JOB NO. B94DK71A

PORT ALLEN SMALL BOAT HARBOR FLOATING DOCK IMPROVEMENTS

JOB NO. B94DK71A PORT ALLEN SMALL BOAT HARBOR PIER IMPROVEMENTS, KAUAI, HAWAII

AS-BUILT
08/31/2018

ELECTRICAL PLAN

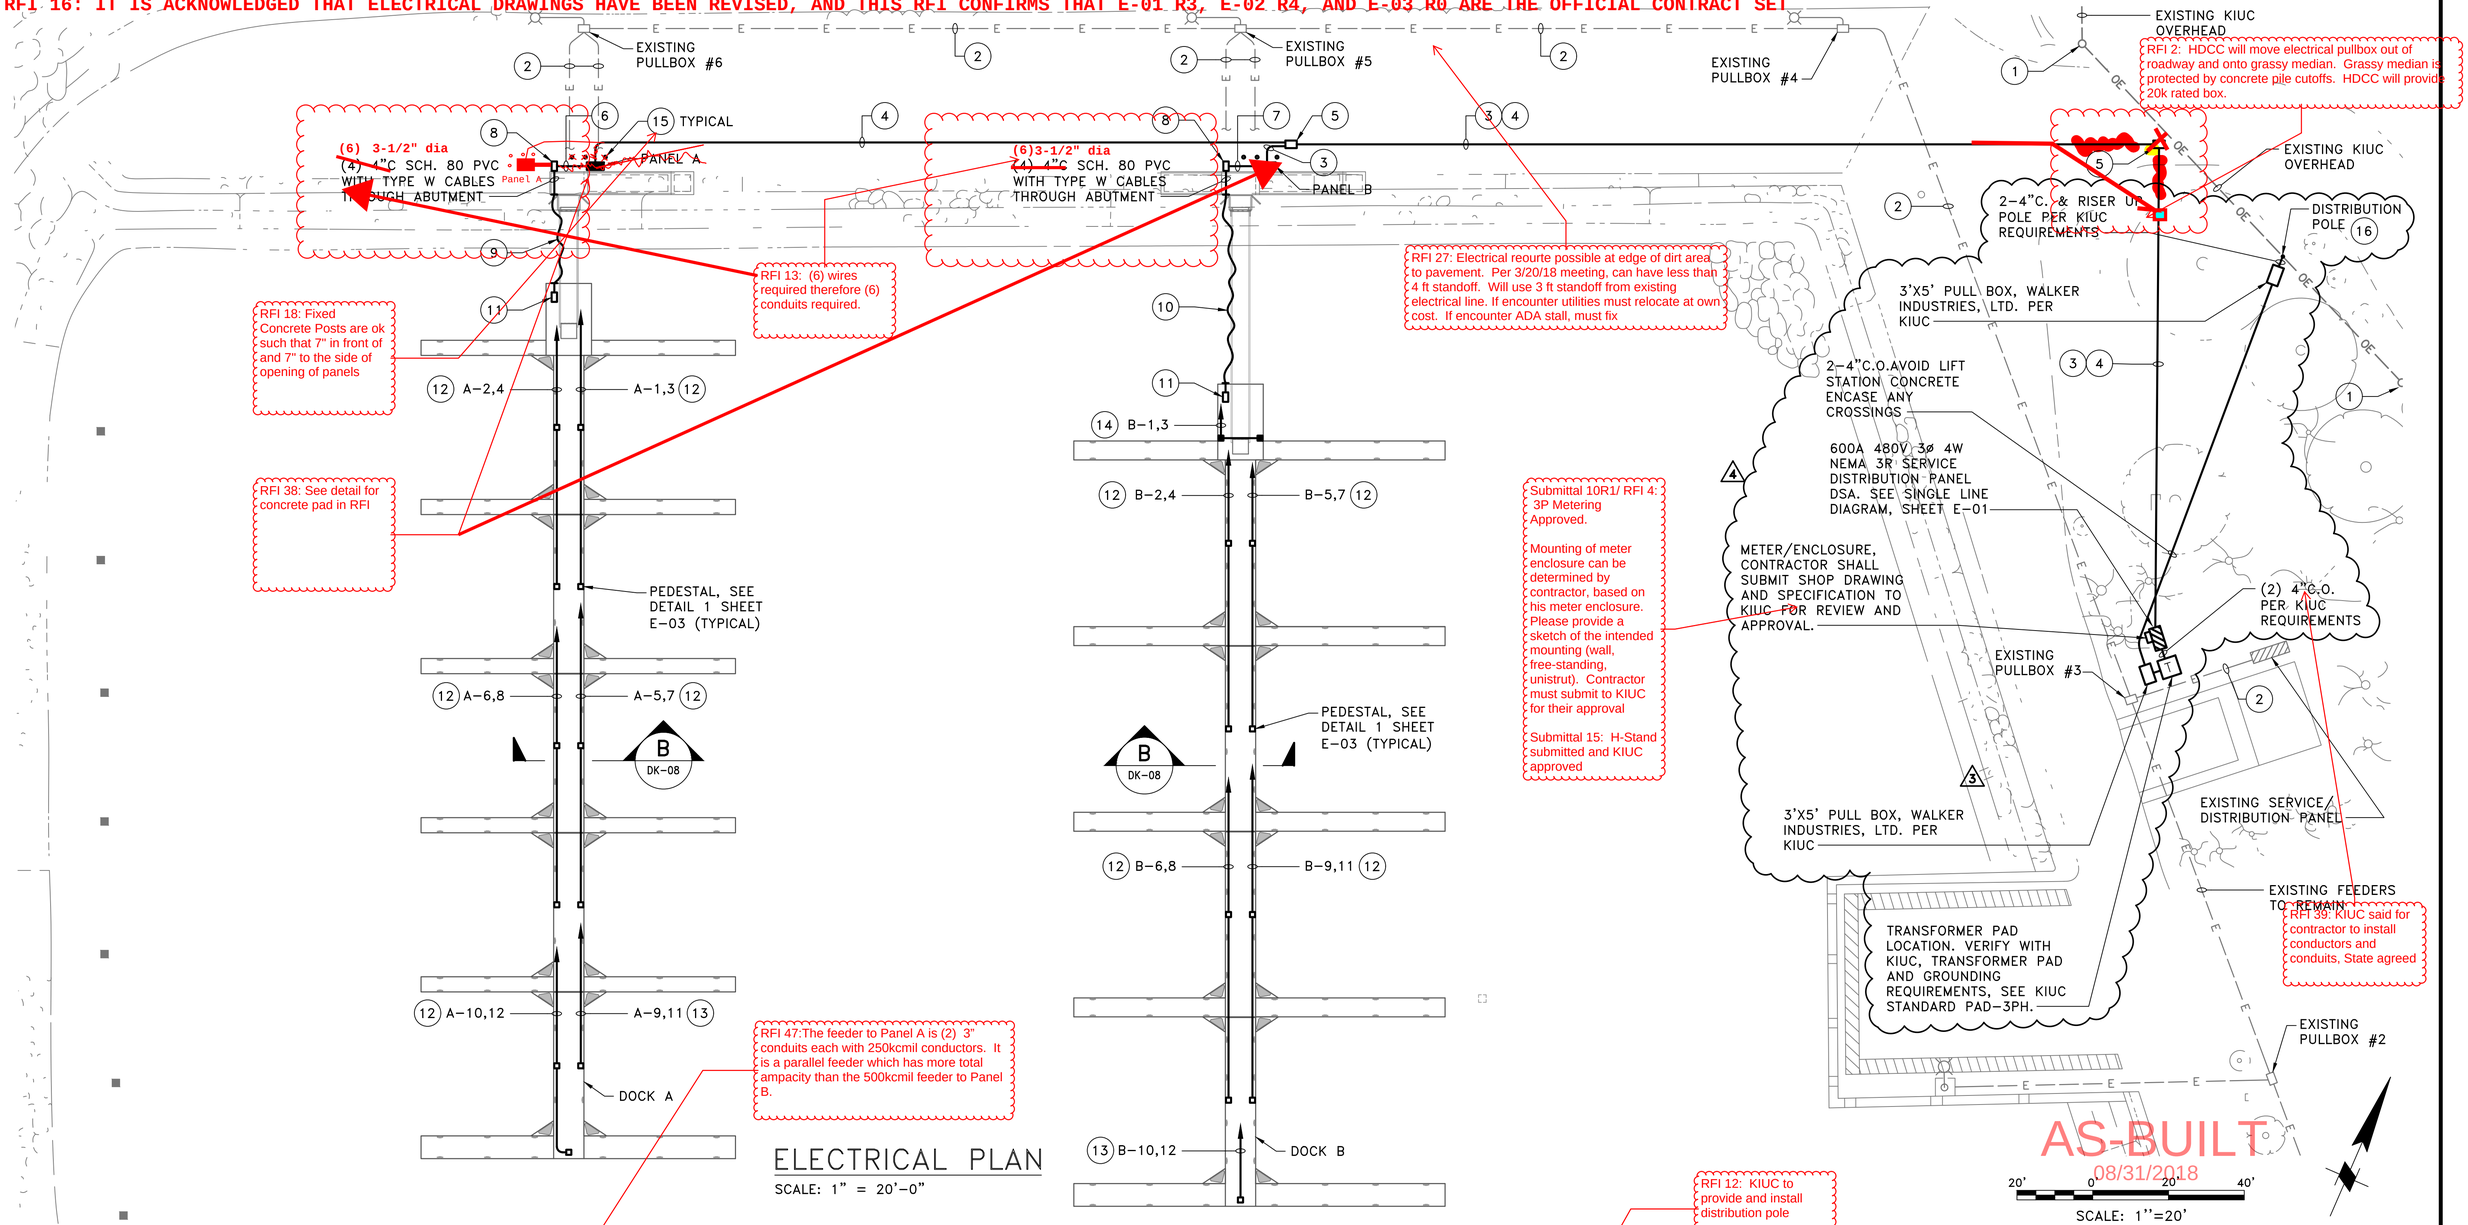
RFI 16: IT IS ACKNOWLEDGED THAT ELECTRICAL DRAWINGS HAVE BEEN REVISED, AND THIS RFI CONFIRMS THAT E-01 R3, E-02 R4, AND E-03 R0 ARE THE OFFICIAL CONTRACT SET

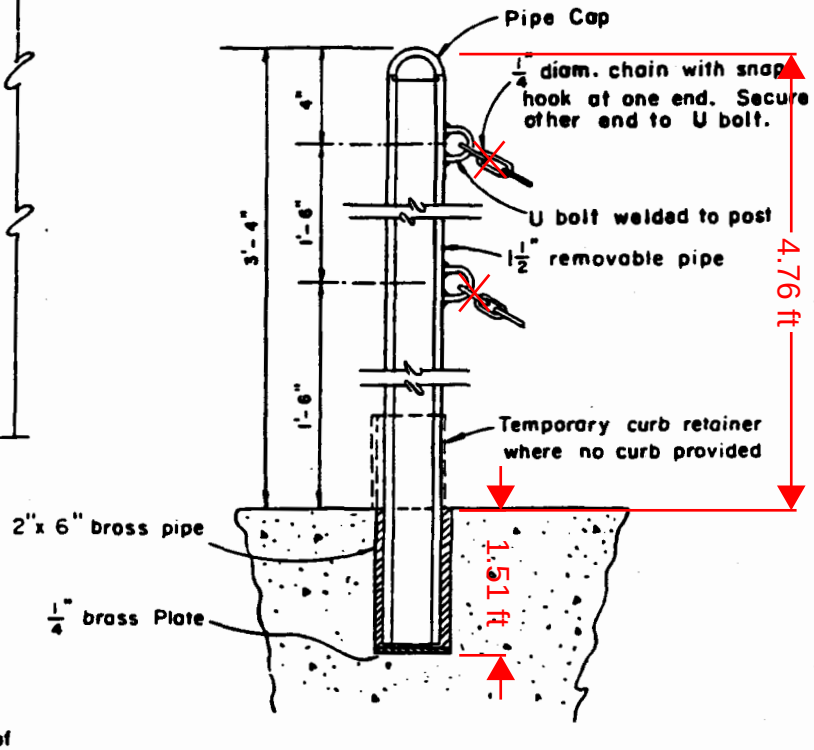
RFI 18: GUARD POST DETAIL OMITTED, ADDED STANDARD C&C OF KAUAI DETAIL

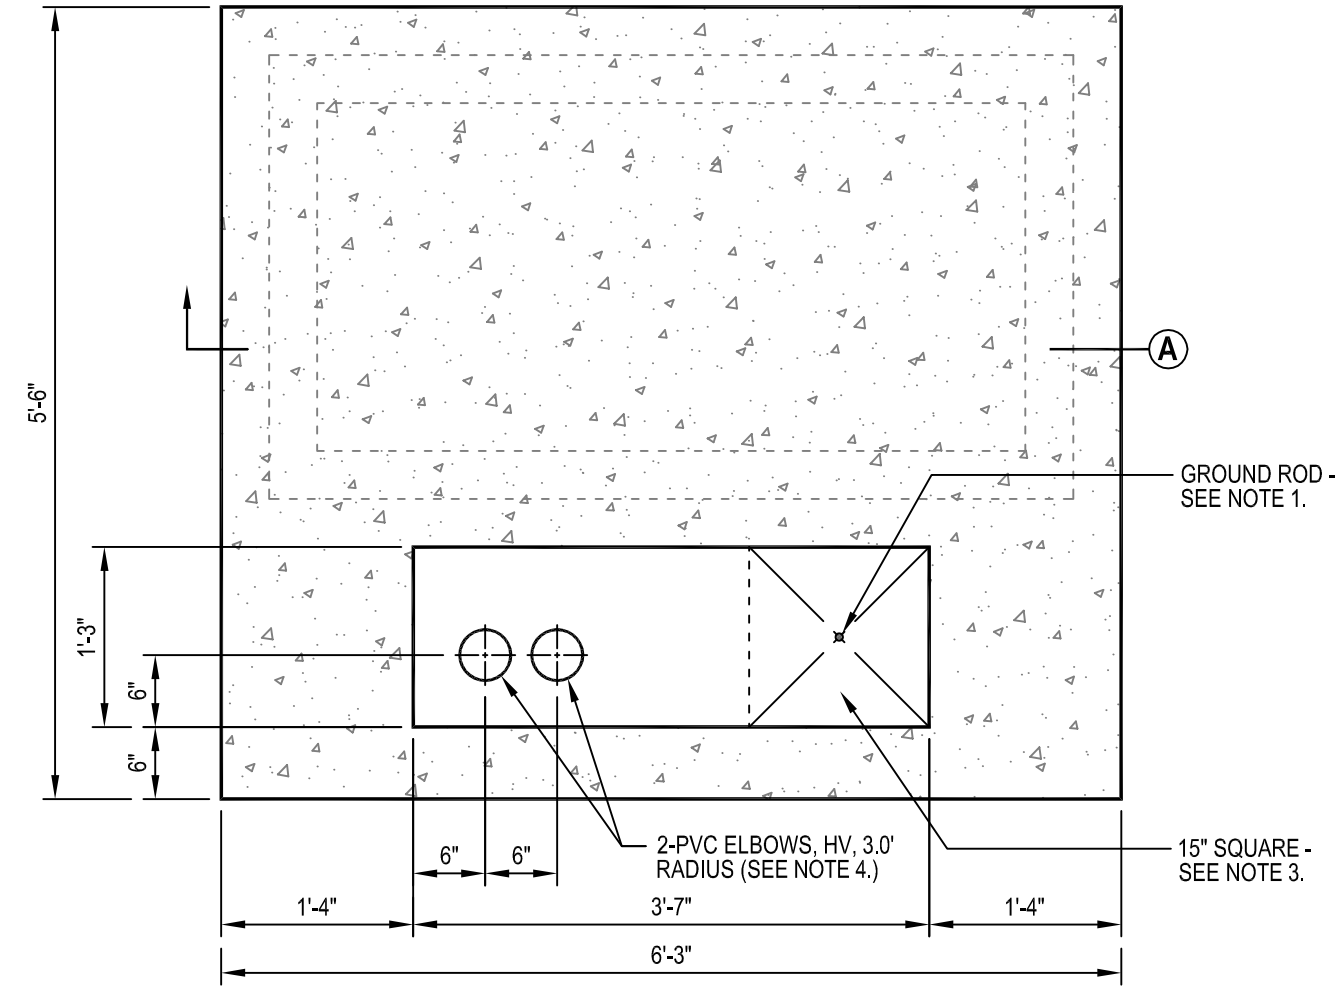
RFI 16: Revised Elec Dwgs, KIUC TRANSFORMER PAD, STANDARD DETAIL added

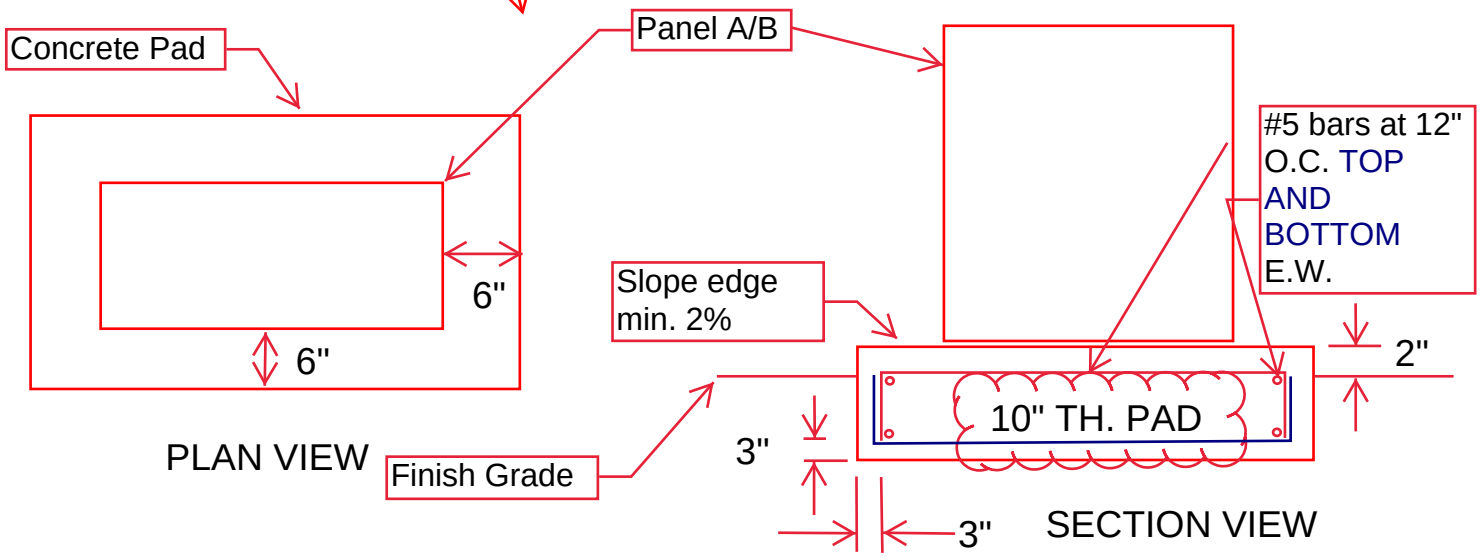
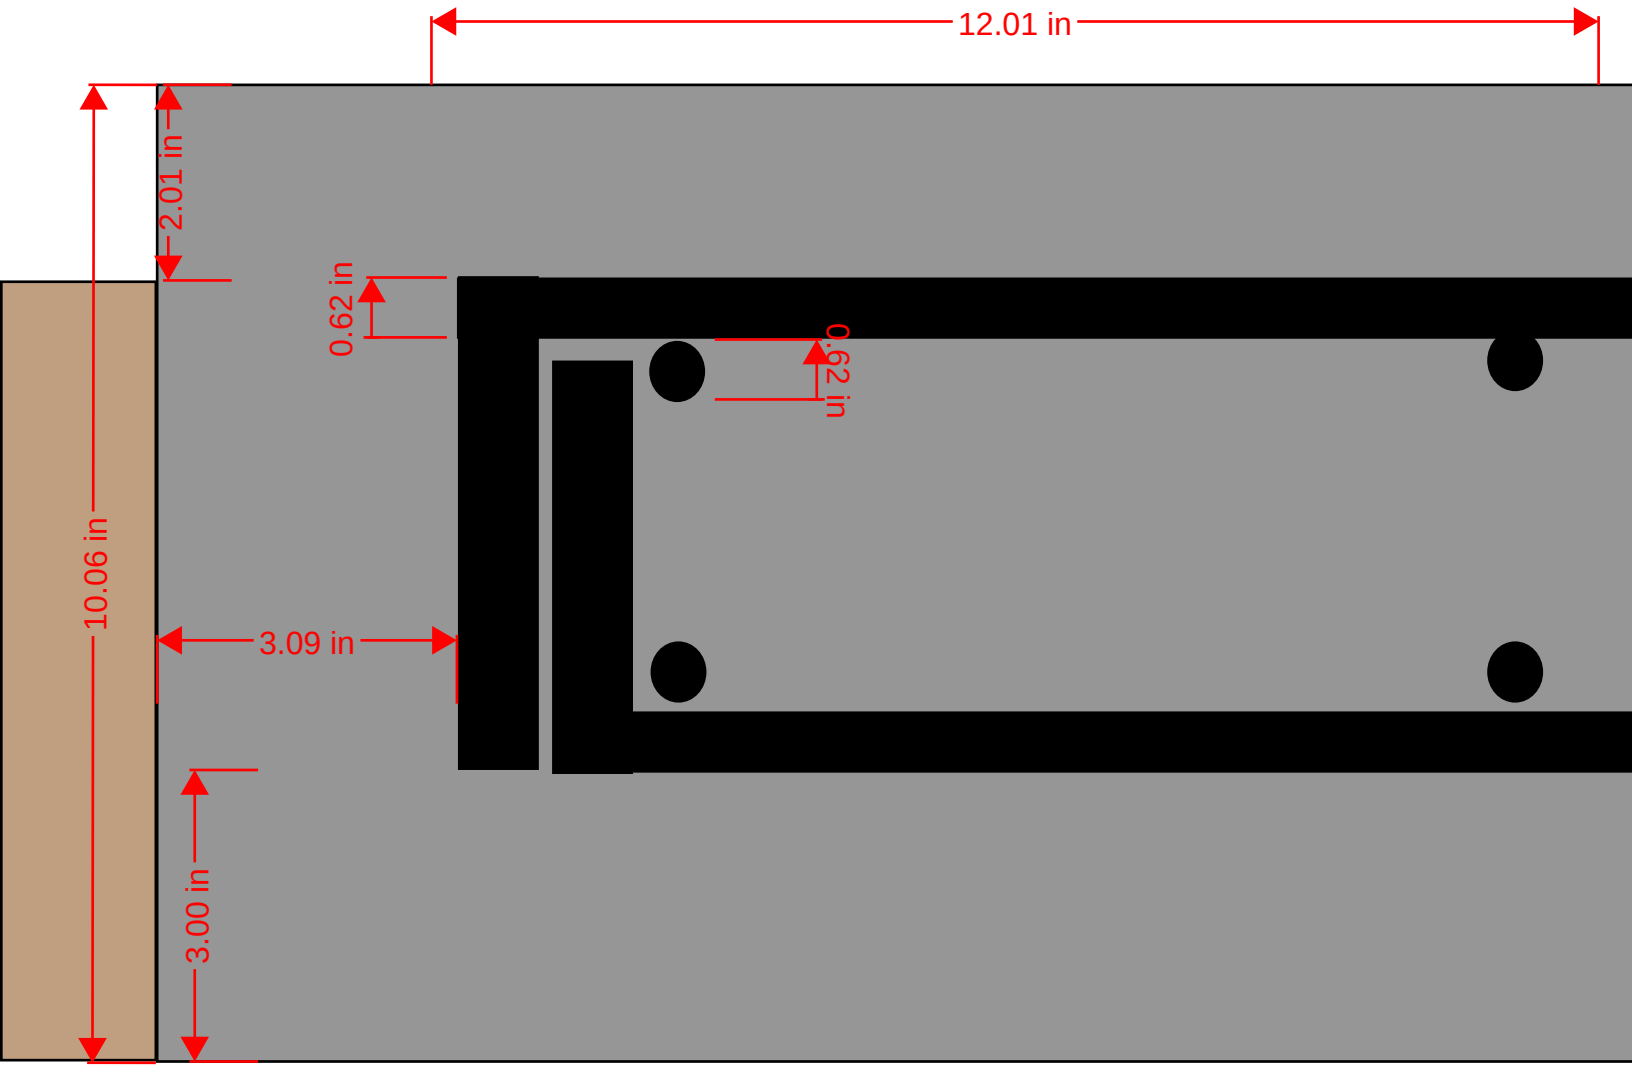
RFI 38: Panel Pad Detail

Please provide a detail for the concrete pad for the panels.
